SI B18 02 12  
Exhaust Systems

This Service Information bulletin supersedes SI 18 02 12 dated May 2012.

**Voluntary Emissions Recall Campaign 11E-A03: Check and/or Replace Emissions Monitoring Components**

E70 and E90 with the M57Y engine produced from January 2008 to September 2009

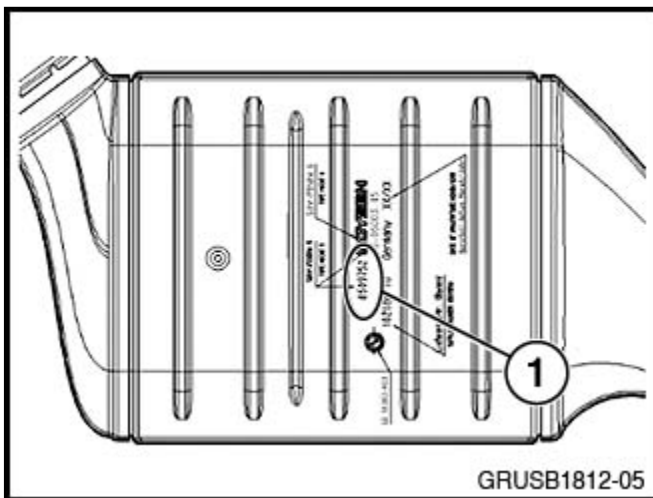
**NEW** Check the part number of the SCR catalyst (1). If the part number is not 18 30 8 509 752/753 (E70) or 18 30 8 509 749/750 (E90), the SCR catalyst will need to be replaced.

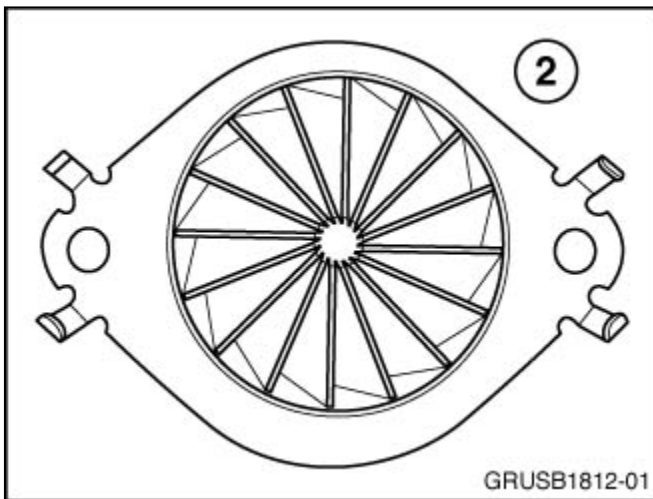
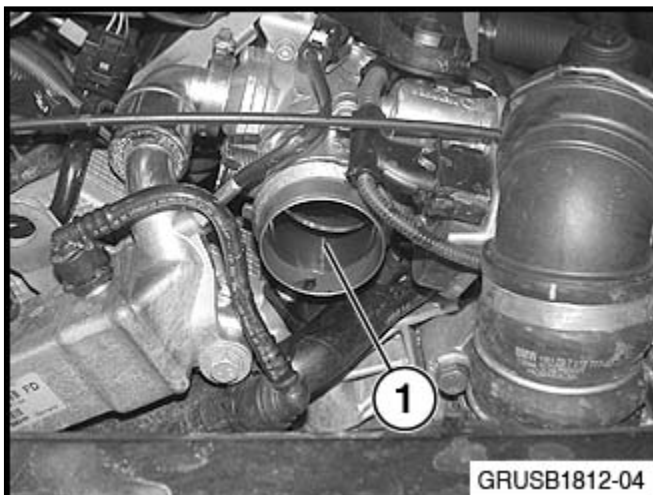
The original style mixer has a multiple

fin arrangement (1). This mixer will need to be replaced with P/N 18 30 8 513 445 (E70) or P/N 18 30 8 512 438 (E90).

If the updated mixer has already been installed, it will have one set of fins (2). No replacement is necessary. Reinstall the SCR front pipe to the down pipe of the DPF.

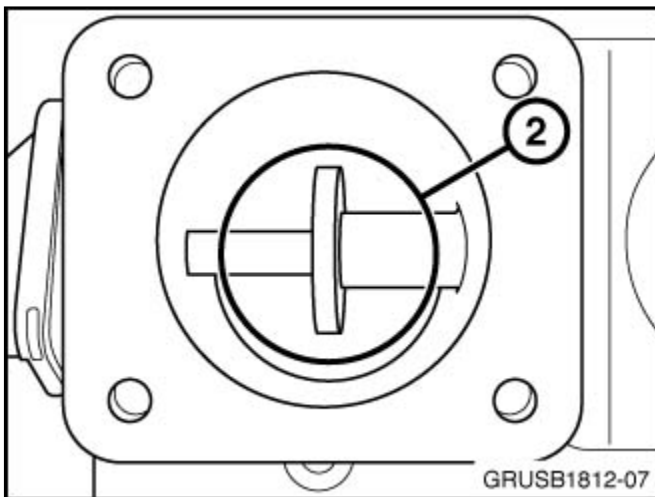
The updated EGR valve (P/N 11 71 8 517 217 or P/N 11 71 8 512 526) has the valve and seat directly in the airstream of the throttle (1). If this valve is installed, no further action is needed. Reinstall the charge air pipe.

The original EGR valve has a diffuser in the airstream flow from the throttle (2). The valve for EGR actuation is seated further into the EGR airstream. Replace this valve with P/N 11 71 8 512 526 (Repair Instruction 11 71 501).
